## DEVIATION REVIEW AND DECISION FORM

Subdivision or Project Name: Judge Orr RV Park

Section of ECM from Which Deviation is Sought: 2.4.1.B Access Design Criteria - Access Spacing; 2.3.2 Design Standards by Functional Classification.

Proposed Nature and Extent of Deviation: The request is to allow a centerline spacing of 374 feet between Judge Orr Road and the proposed RV Park Access access/future commercial PUD private street intersection (the future east/west private commercial street, which is planned to align with the RV Park access at Cessna Drive, would extend west from Cessna Drive into the future commercial PUD development site). Please refer to the attached exhibit.

# Phase 1 Proposed Traffic Lanes

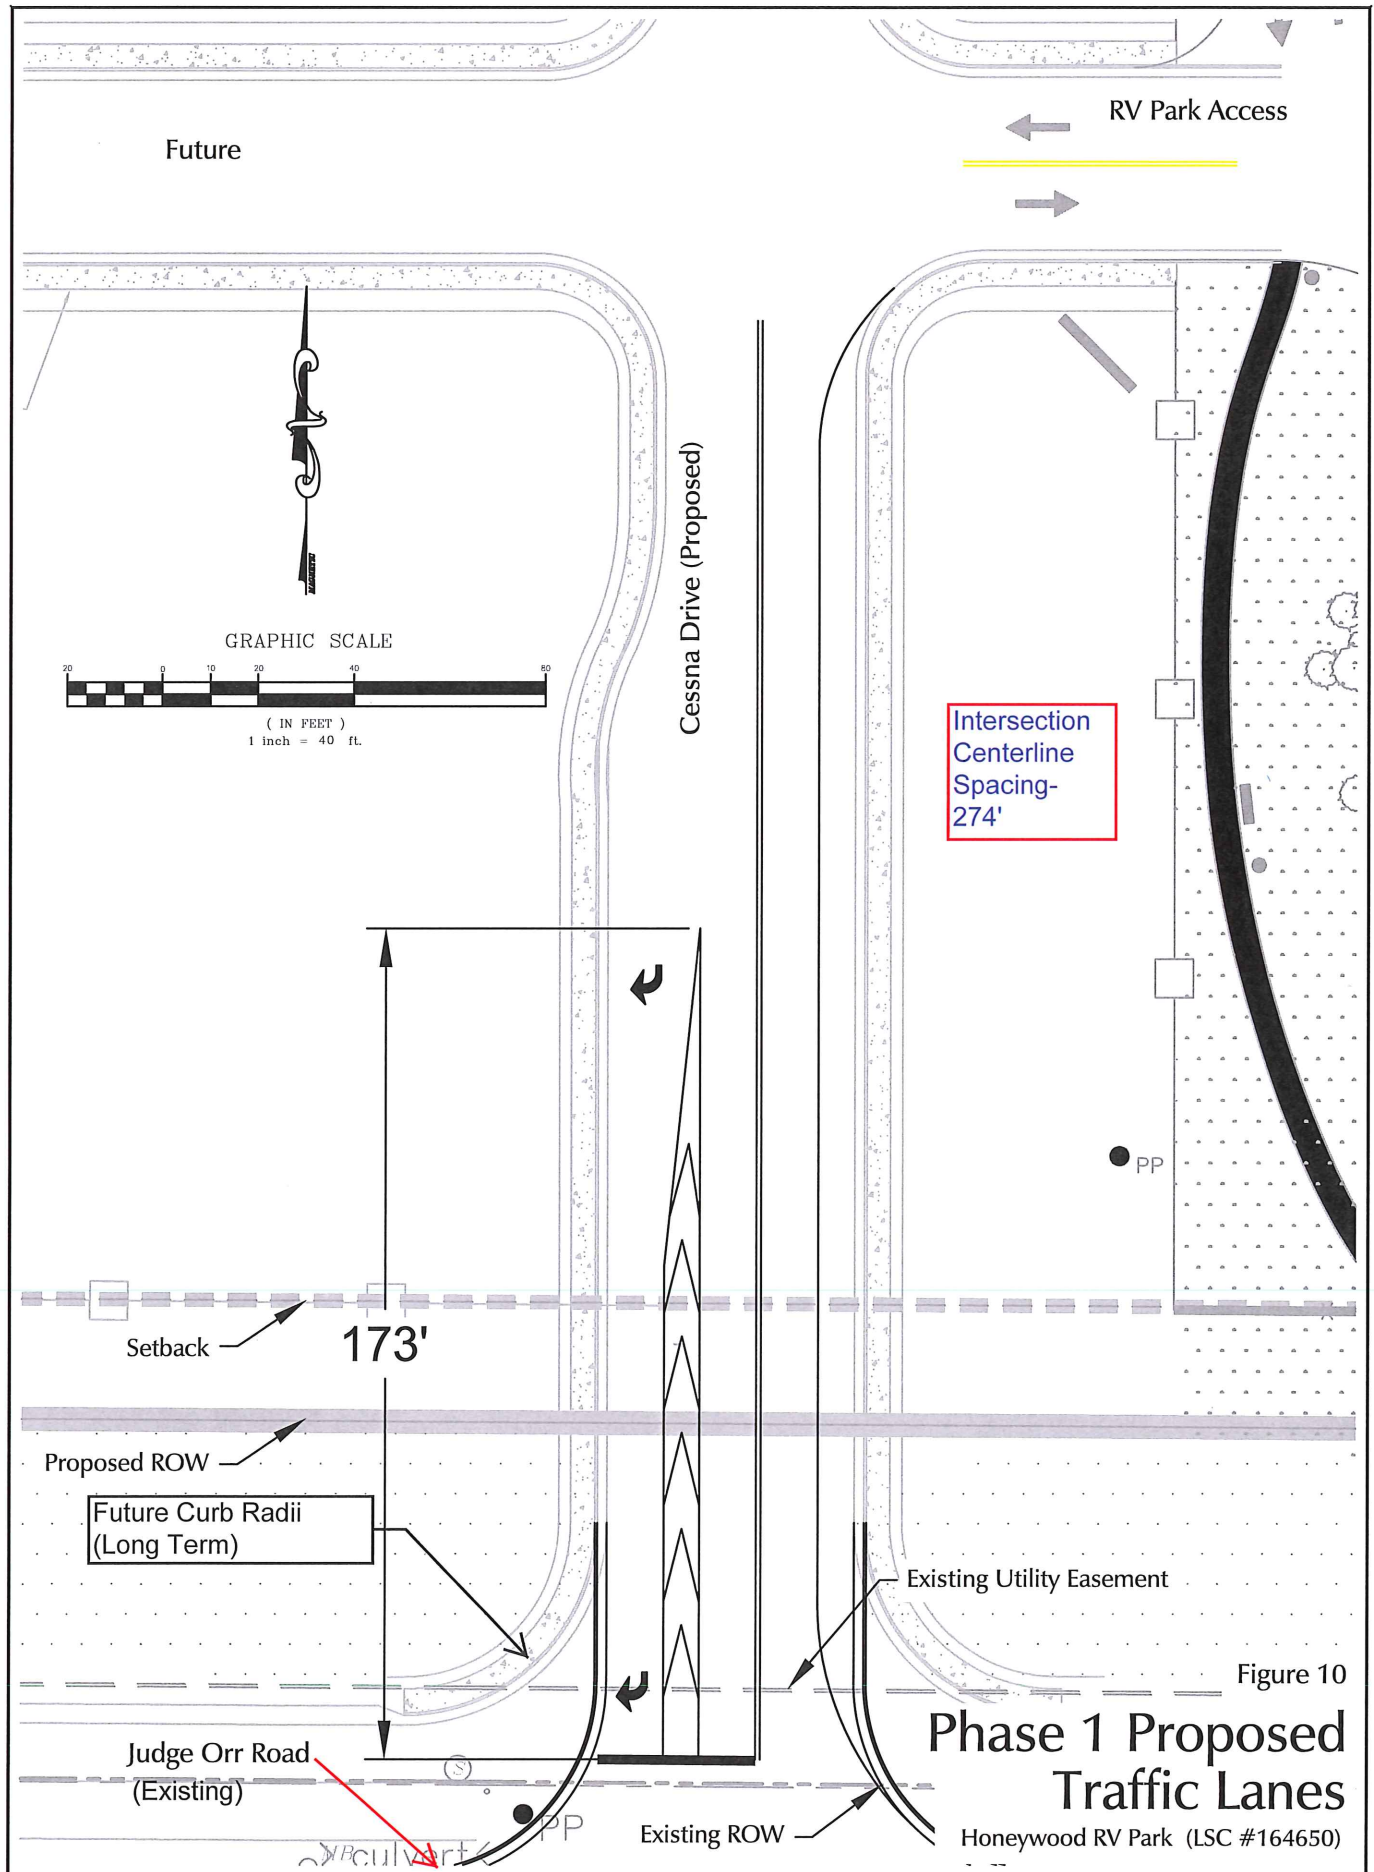
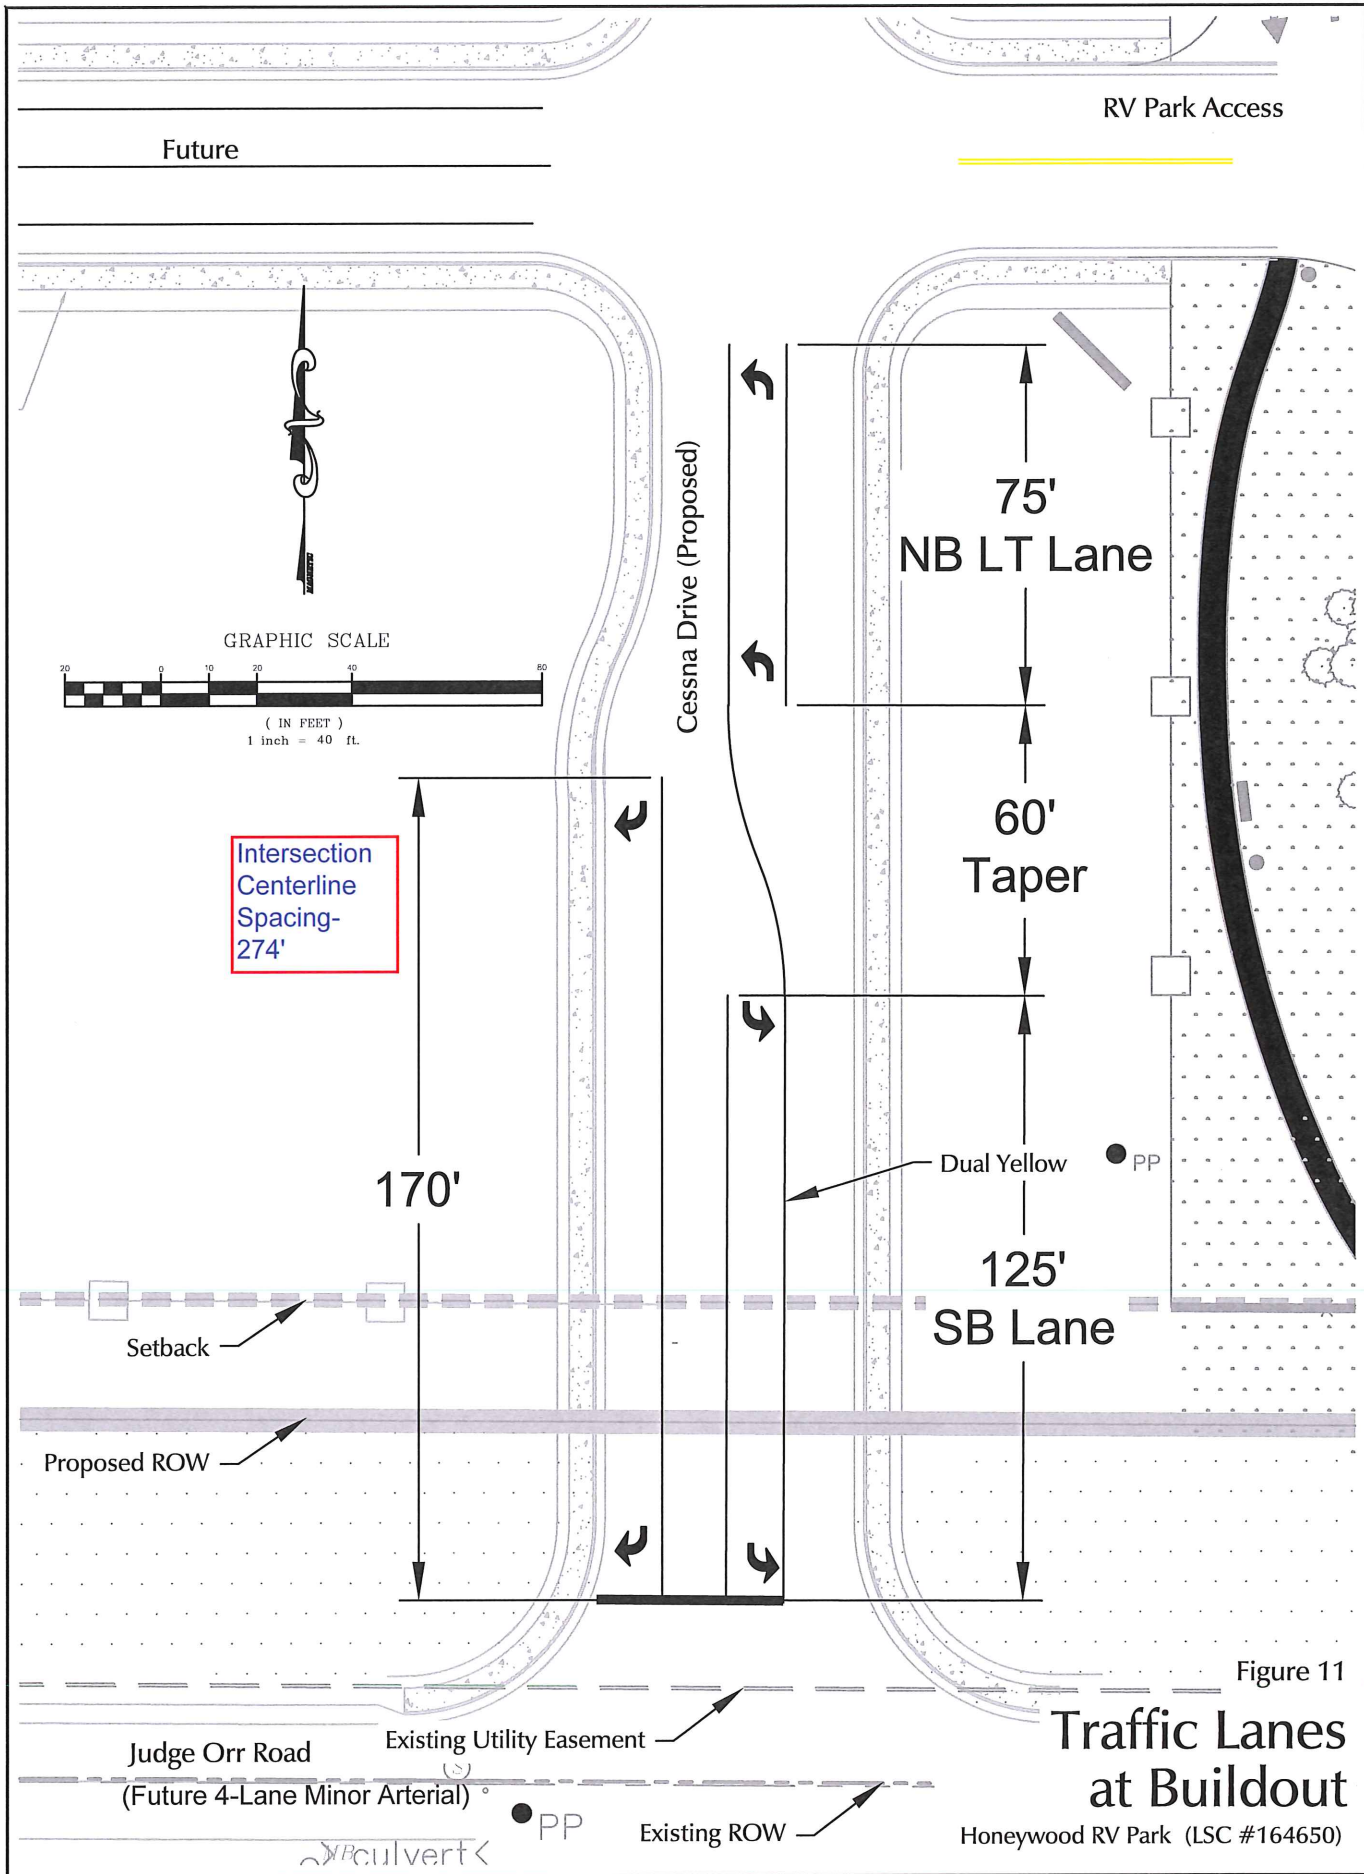
The 2040 queuing analysis contained in the TIS indicates that the proposed intersection spacing will be sufficient to accommodate vehicle turning movements, projected vehicle queues, turn lanes of sufficient length and associated tapers (please refer to separate deviation for turn lane lengths), sufficient stopping sight distance and intersection sight distance based on this site-specific analysis. Please refer to the attached exhibits showing the intersection spacing and laneage plan for Cessna Drive north of Judge Orr Road.
